Change Number M-24-00-02	Federal Facility Agreement and Consent Order Change Control Form <small>Do not use blue ink. Type or print using black ink.</small>	May 22, 2001									
Originator Jane Hedges, Ecology		Phone 509-736-3016									
Class of Change <input type="checkbox"/> I - Signatories <input checked="" type="checkbox"/> II - Executive Manager <input type="checkbox"/> III - Project Manager											
Change Title Establish calendar year 2001 RCRA well installation interim milestones in support of Hanford Federal Facility Agreement and Consent Order (HFFACO) Major Milestone M-24-00M.											
Description/Justification of Change <p style="text-align: center;"><u>Introduction:</u></p> Regulatory requirements applicable to the generation, transport, storage, treatment, and/or disposal of hazardous and mixed wastes are established by the <i>Resource Conservation and Recovery Act of 1976 (RCRA)</i> , Washington's Hazardous Waste Management Act (HWMA), and the HFFACO, as amended. The Hanford Facility RCRA Permit was issued by the Washington State Department of Ecology (Ecology) and the United States Environmental Protection Agency (EPA) in August 1994. Ecology and EPA designat

**WMA S-SX
Proposed Well
Locations and
Surrounding
Facilities**

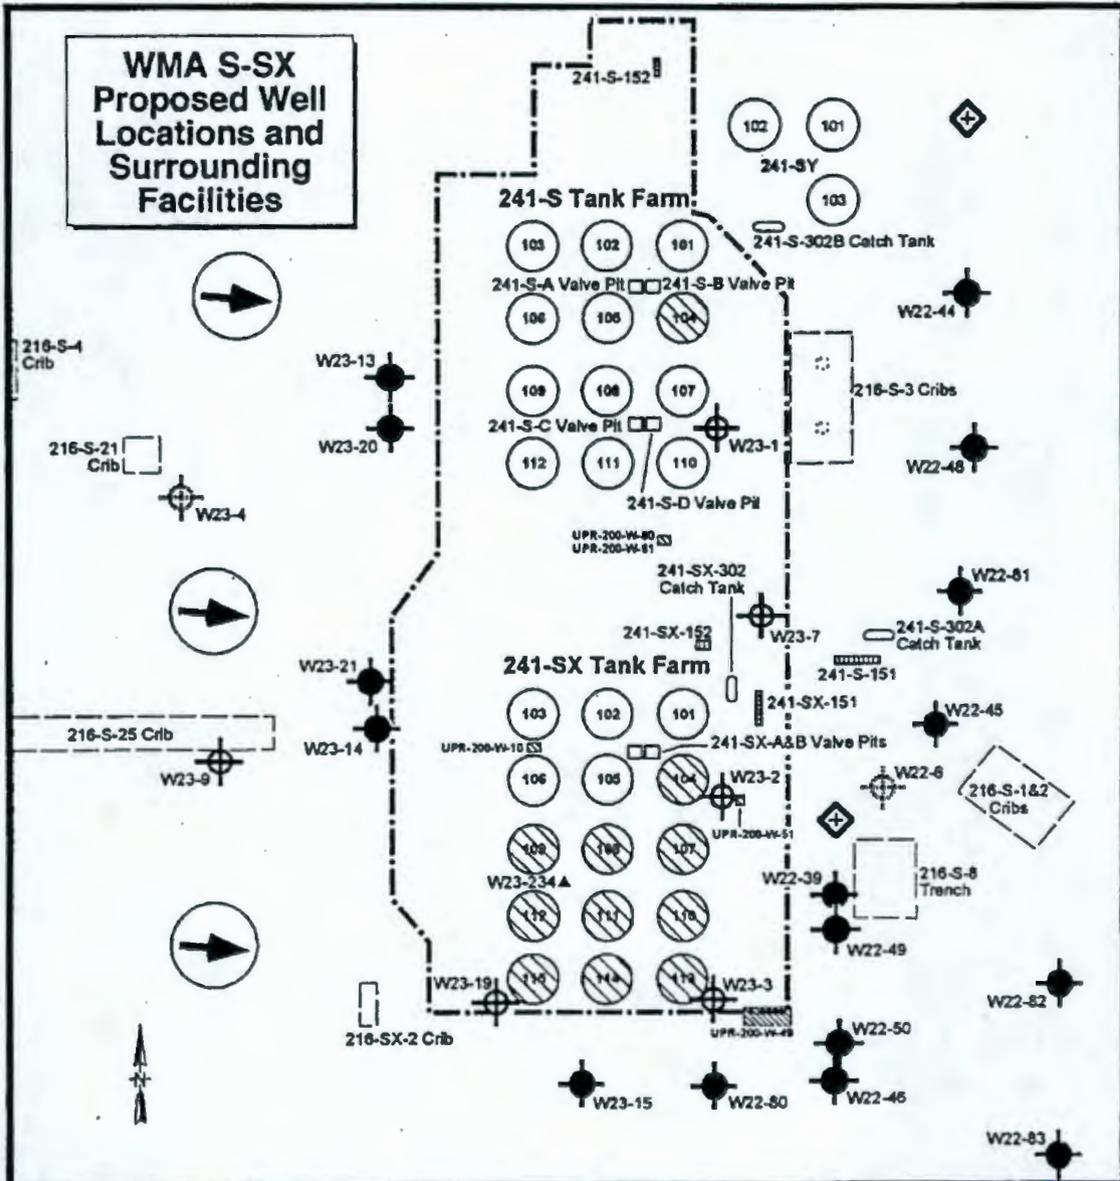
M-24-51	Install three (3) additional wells at SST WMA B-BX-BY	December 2001	Location: All wells installed downgradient at perimeter of WMA.
M-24-52	Install three (3) additional wells at SST WMA U	December 2001	Location: Two wells installed downgradient at perimeter of WMA and one well installed upgradient of WMA.
M-24-53	Install two (2) additional wells at SST WMA TX-TY	December 2001	Location: One well installed downgradient at perimeter of WMA and one well installed upgradient of WMA.
M-24-54	Install one (1) additional well at SST WMA T	December 2001	Location: One well installed upgradient of WMA.
M-24-55	Install two (2) additional wells at SST WMA S-SX	December 2001	Location: Two wells installed downgradient at perimeter of WMA.

S-SX	D	Y	0**	Site in assessment. Evaluate contaminant depth distribution. Proposed for current year drilling campaign (priority ii).	X	Downgradient assessment well southeast of facility, adjacent to mid-field well being drilled this year east of 299-W23-3.
S-SX	E	See →	Defer*	Site in assessment. Evaluate contaminant depth distribution.	X	Downgradient (perimeter), if needed. Evaluate current year's findings before deciding need/location. Part of C well cluster.
T	A	Y	3	Site in assessment. Evaluate horizontal and vertical extent of contamination.	X	Downgradient assessment well, location will be decided after data from current year's wells have been evaluated. Currently located south of the 216 T-17 Trench as a placeholder.
T	B	Y	0**	Site in assessment. Monitor contamination with depth. Proposed for current drilling campaign (priority iii).	X	Downgradient assessment well located near well #C3117 of this year's drilling.

**WMA T
Proposed Well
Location and
Surrounding
Facilities**

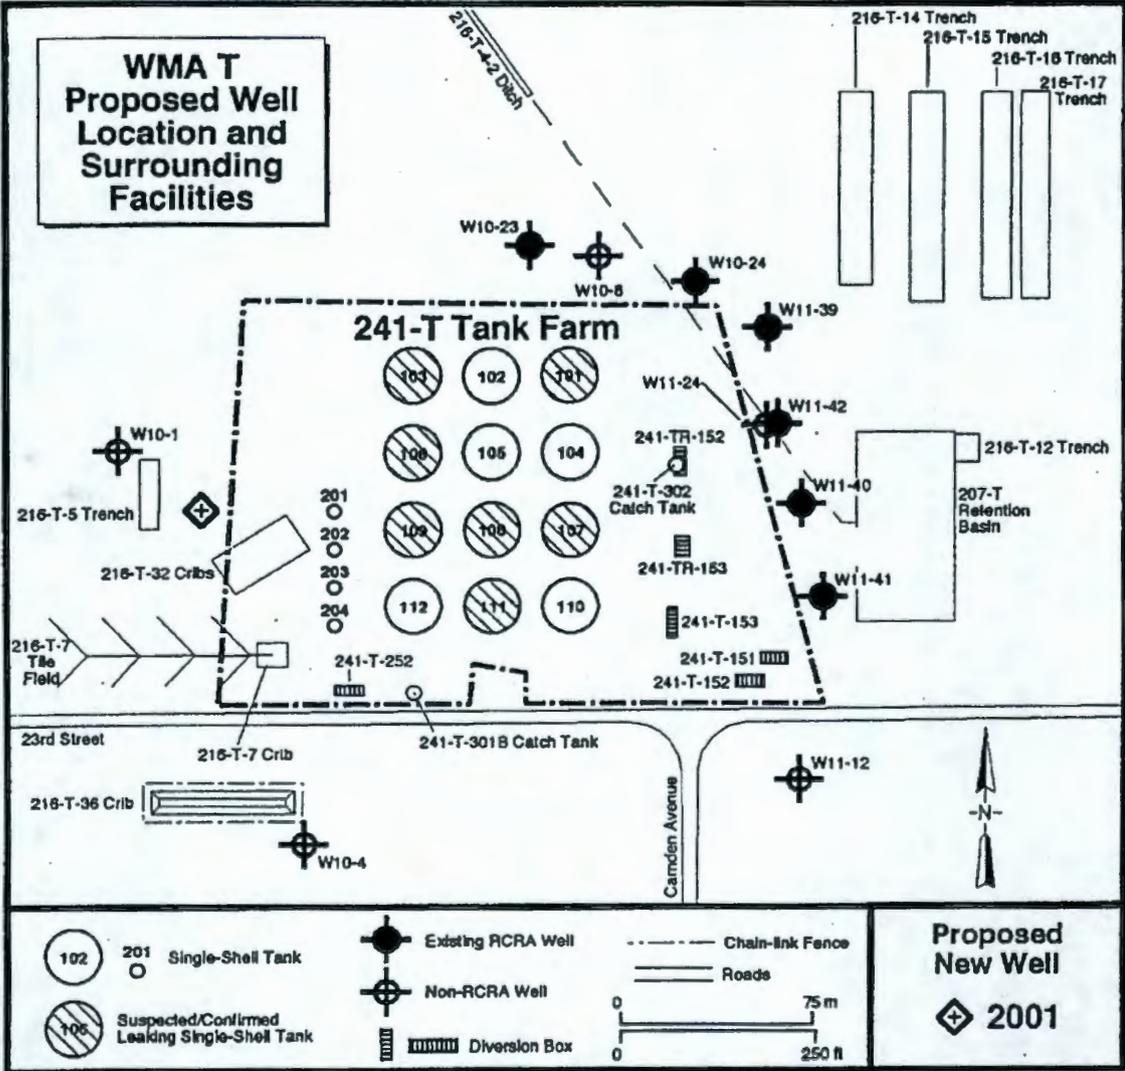
T	C	Y	2	Site in assessment. Evaluate contaminant depth distribution, monitor at depth.	X	Downgradient assessment well located near well #C3118 of this year's drilling.
T	D	Y	1	Site in assessment. Upgradient well		Upgradient. Replaces non-RCRA well 299-W10-1.
C	A	See →	Defer*	Determine flow directions, proceed step-wise.		Downgradient perimeter well.
C	B	See →	Defer*	Determine flow directions, proceed step-wise.		Downgradient perimeter well.
A-AX	A	See →	Defer*	Determine flow directions, proceed step-wise.		Downgradient perimeter well.
A-AX	B	See →	Defer*	Determine flow directions, proceed step-wise.		Downgradient perimeter well.
U-12 Crib	A	See →	Defer***	Site in assessment; non-Tank Farm site.		
U-12 Crib	B	See →	Defer***	Site in assessment; non-Tank Farm site.		
S-10 Pond	A	See →	Defer***	Site in detection; non-Tank Farm site.		
LLBG	A	See →	Defer***	Site in detection; non-Tank Farm site.		
LLBG	B	See →	Defer***	Site in detection; non-Tank Farm site.

**WMA TX-TY
Proposed Well
Locations and
Surrounding
Facilities**

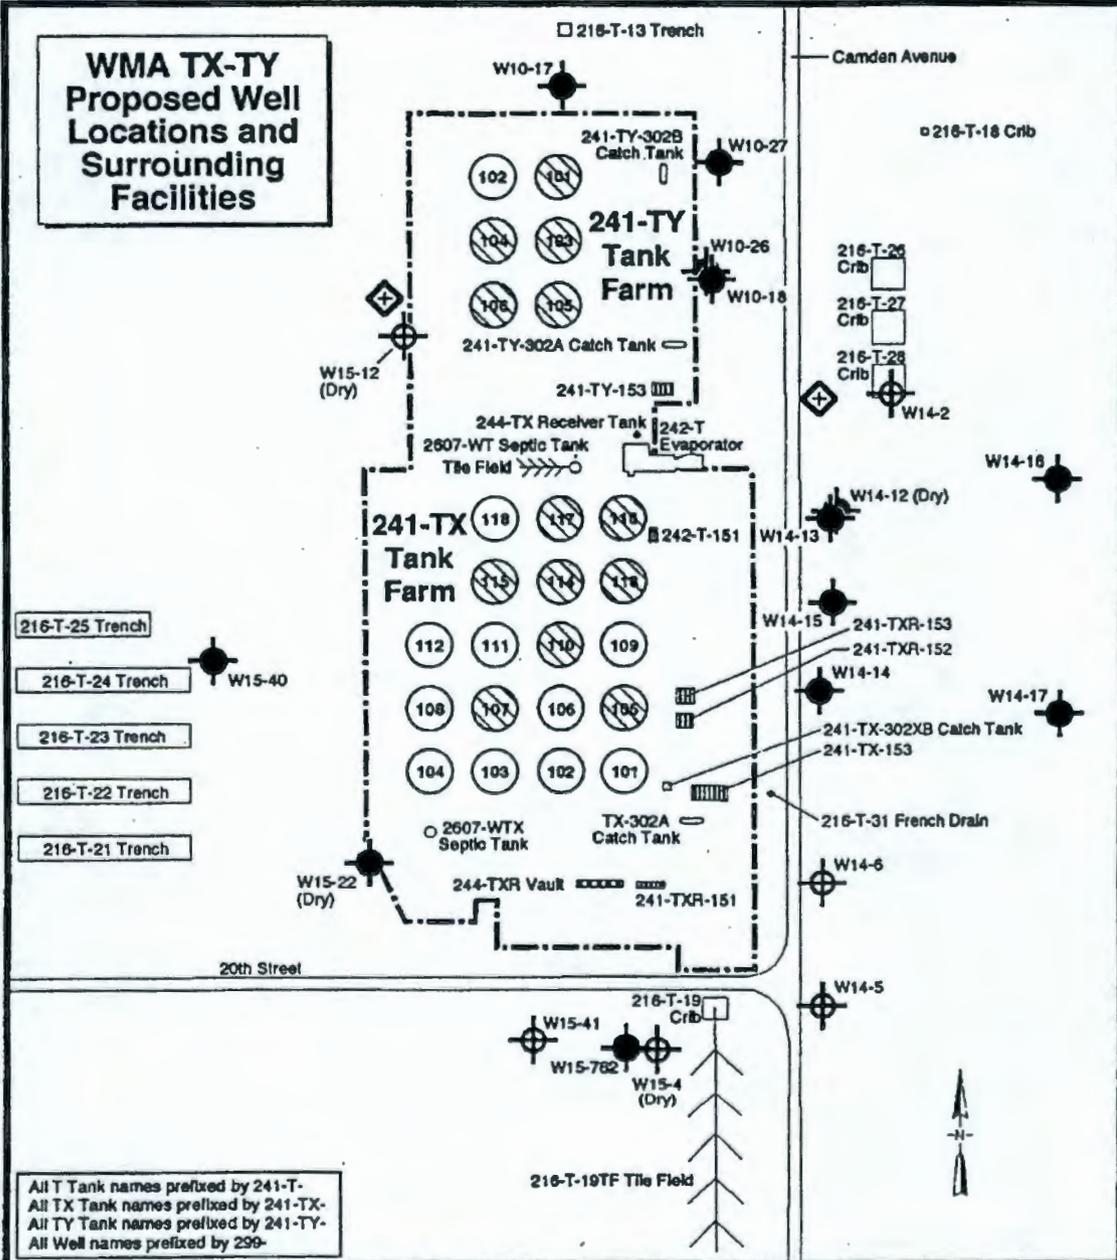
TX-TY	A	Y	1	Site in assessment. Contaminant detection/enhance downgradient coverage		Downgradient (perimeter), near non-RCRA well 299-W14-2.
TX-TY	B	Y	5	Site in assessment. Evaluate contaminant depth distribution, monitor at depth.	X	Downgradient assessment well, monitor at depth near well 299-W14-2.
TX-TY	C	Y	3	Site in assessment. Contaminant detection/enhance downgradient coverage		Downgradient (perimeter), located between wells 299-W14-6 and 299-W14-14.
TX-TY	D	Y	6	Site in assessment. Evaluate contaminant depth distribution, monitor at depth.	X	Downgradient assessment well, monitor at depth near well 299-W14-13.
TX-TY	E	Y	4	Site in assessment. Contaminant detection/enhance downgradient coverage		Downgradient (perimeter), located west of 299-W15-41.

Facility Name	Well ID	Keep on List?	Well Priority	Justification/Purpose	Deep Well	Location
TX-TY	F	Y	7	Site in assessment. Evaluate contaminant depth distribution, monitor at depth.	X	Downgradient assessment well, located adjacent to 299-W15-41.
TX-TY	G	Y	2	Site in assessment. Upgradient well		Upgradient, north end of the west side of the facility. Replaces drying well 299-W15-12.
TX-TY	H	Y (Added)	0**	Proposed for current drilling campaign (priority i).	X	Downgradient assessment well, located adjacent to newly installed well 299-W14-15.
S-SX	A	Y	1	Site in assessment. Contaminant detection/enhance downgradient coverage		Downgradient (perimeter), toward southern end of east side (well #14 on MEMO simulation).
S-SX	B	Y	2	Site in assessment. Contaminant detection/enhance downgradient coverage		Downgradient (perimeter), on northern end of east side (well #13 on MEMO simulation).
S-SX	C	See →	Defer*	Site in assessment. Contaminant detection/enhance downgradient coverage		Downgradient (perimeter), if needed. Evaluate current year's findings before deciding need/location.
